ABERDEEN MIDDLE SCHOOL
HVAC SYSTEMIC RENOVATION

ADDENDUM NO. 4

DATE: March 27, 2024

PROJECT: Aberdeen Middle School
HVAC Systemic Renovation
111 Mt. Royal Avenue
Aberdeen, Maryland 21001
Gipe Project No. 23043

1
E303 LOWER LEVEL AREA E - POWER
SCALE: 1/8" = 1'-0"

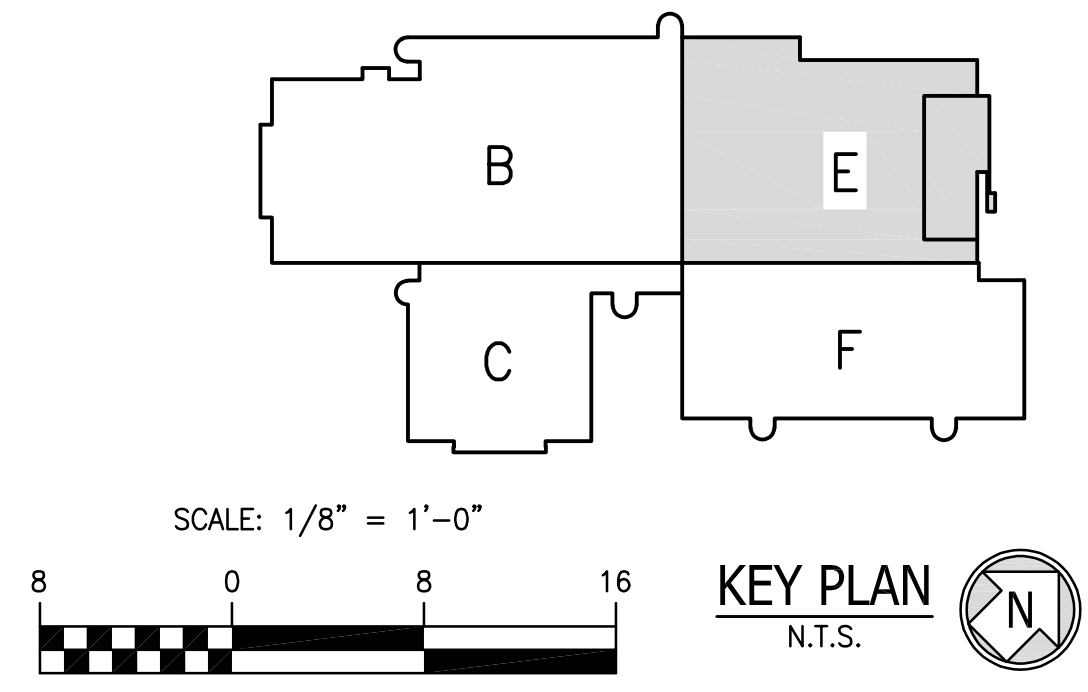
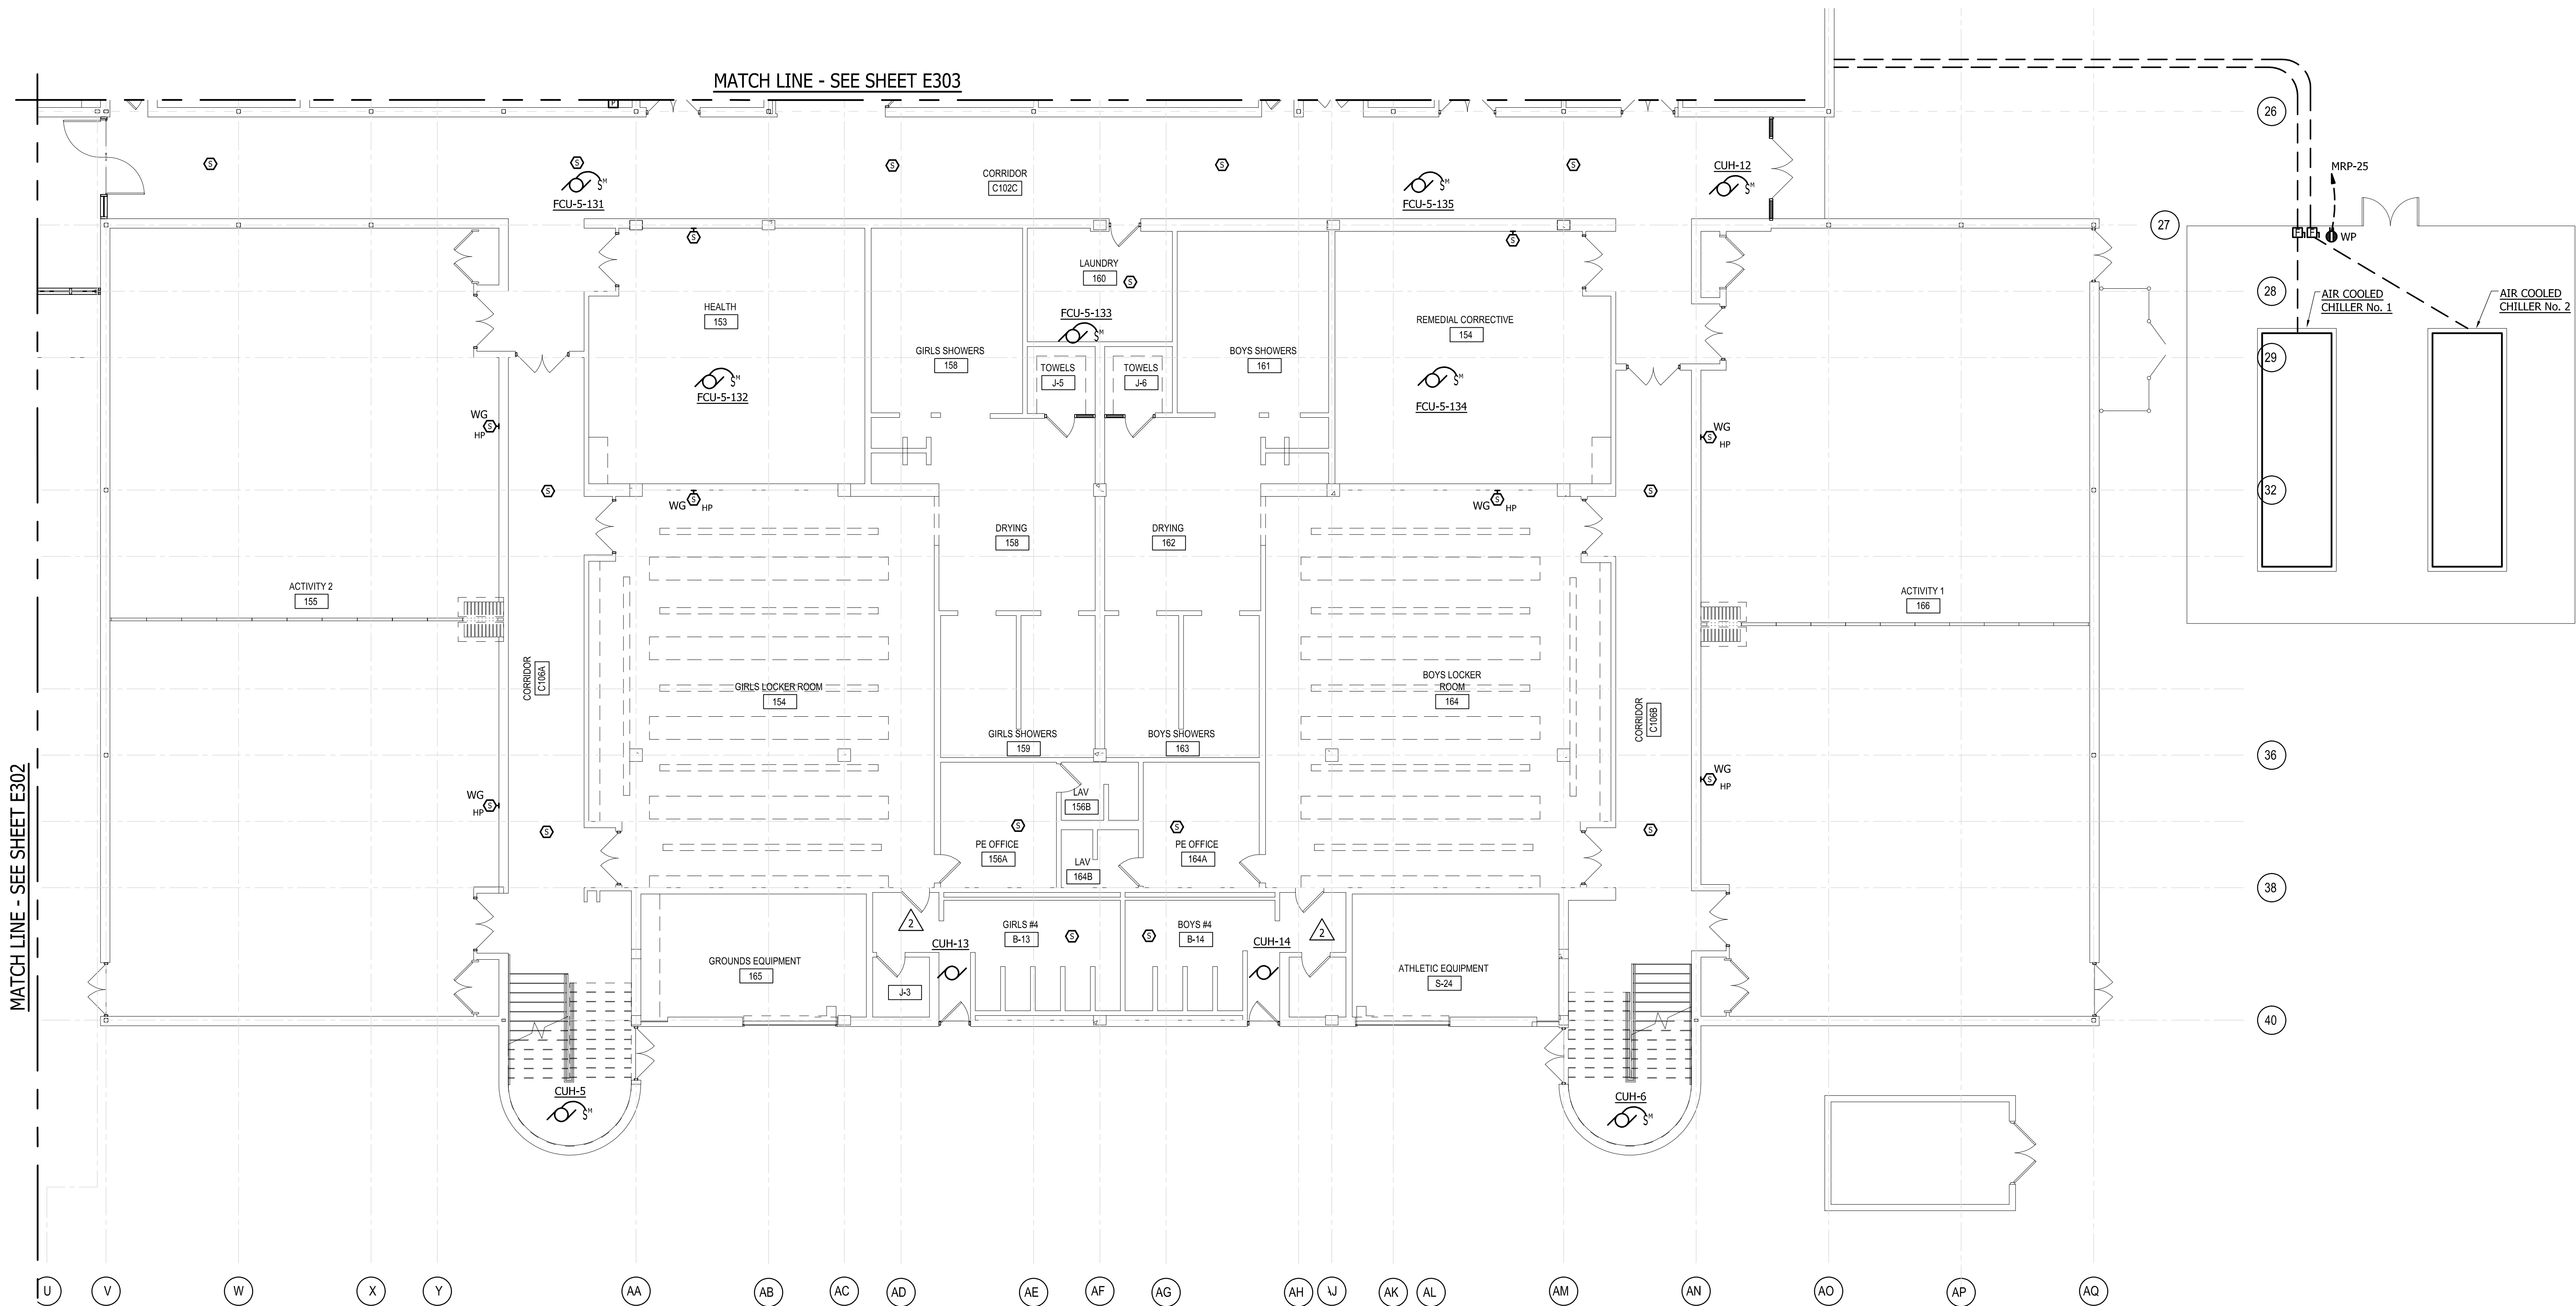
11. **E303 – LOWER LEVEL AREA E – POWER**
Add Fan-5 in Air Handling Unit Room between columns AN and AO and 19 and 20, with associated combination starter located on exterior wall.

Provide new projector high (with duplex receptacle) and projector low drops as indicated on attached drawing. Field coordinate exact location of projector low drops with owner.

Provide PA speakers as indicated on attached drawing.

PLAN SYMBOL: H WALL MOUNTED 84" AFF

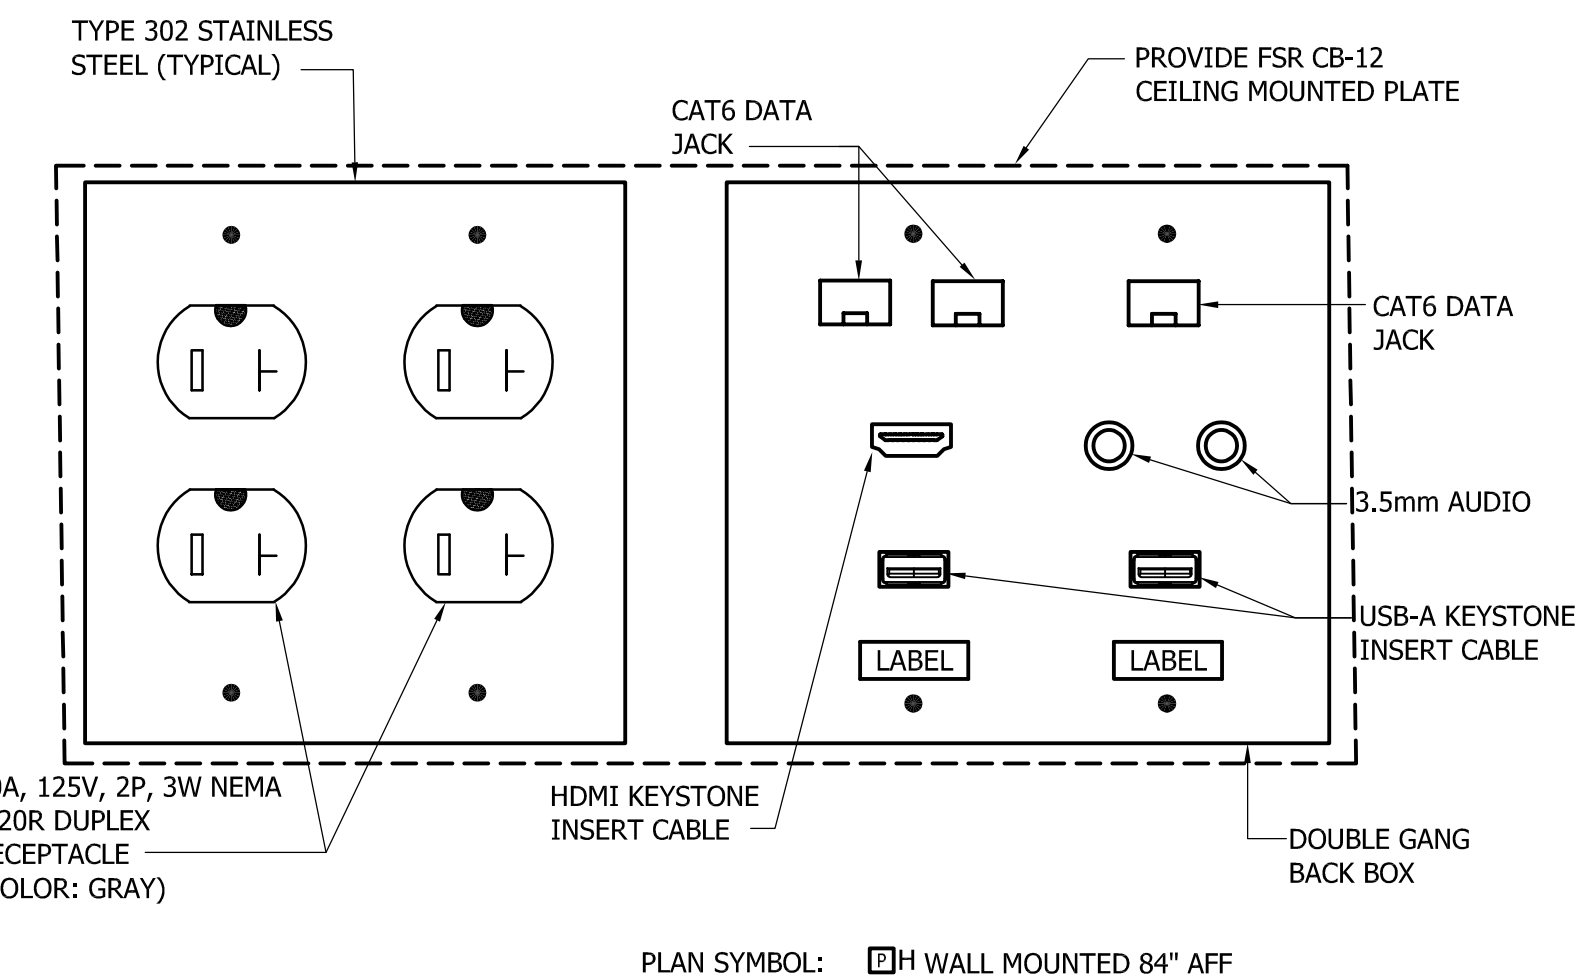
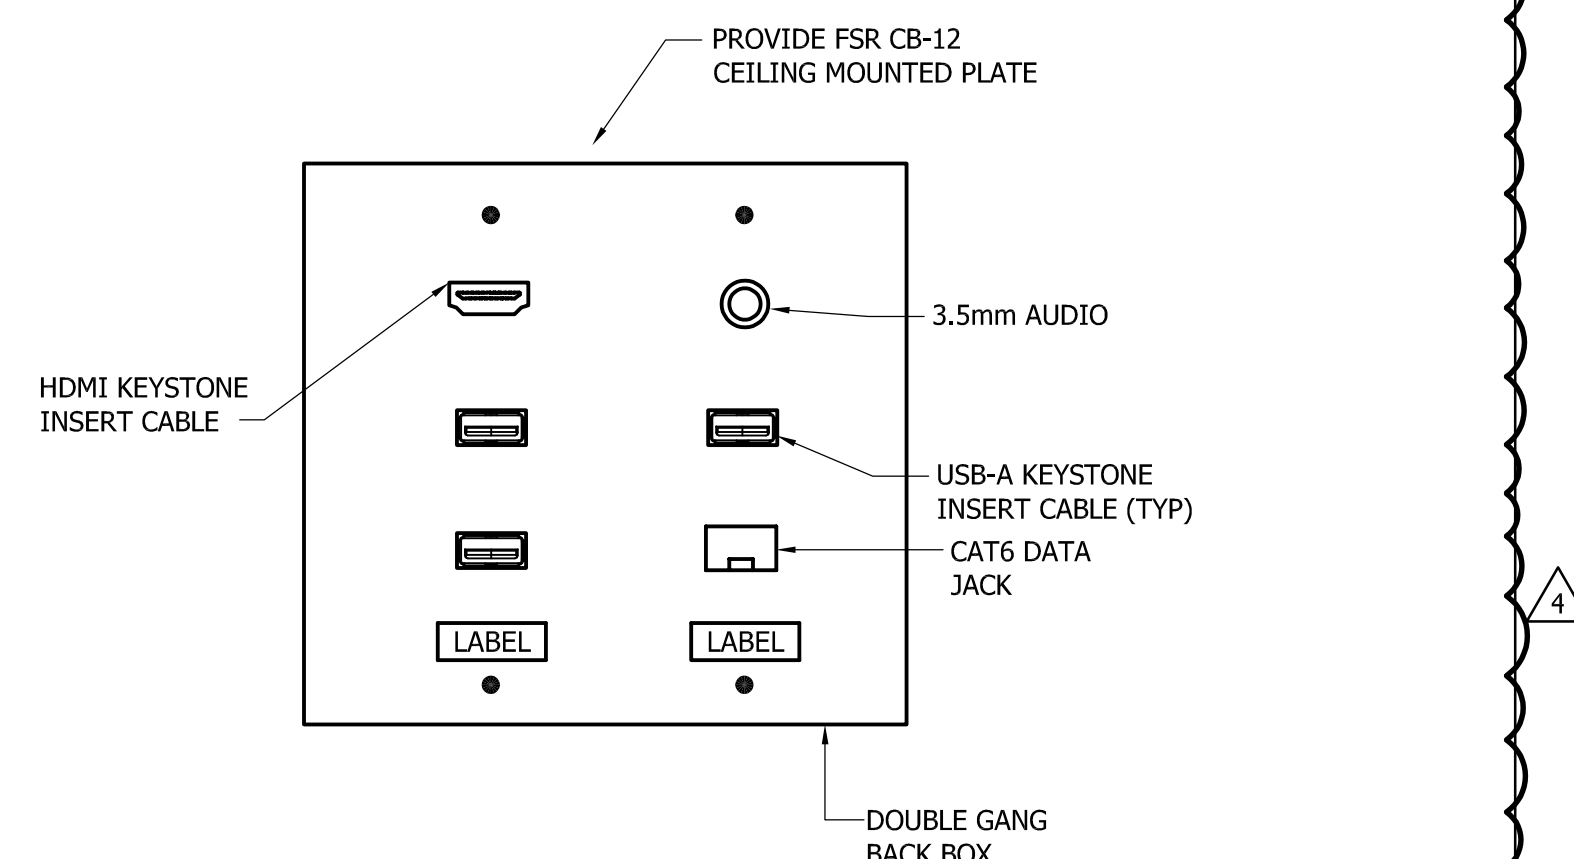
Revise WWSHP-3 on Mechanical Equipment Connection Schedule – Add Alternate #1 circuit to SWBD-7. Revise Amps from "(3)60" to "360." Delete Note 12 reference.
22. **E702 – DETAILS**
Add projector high and low details per attached sheet.
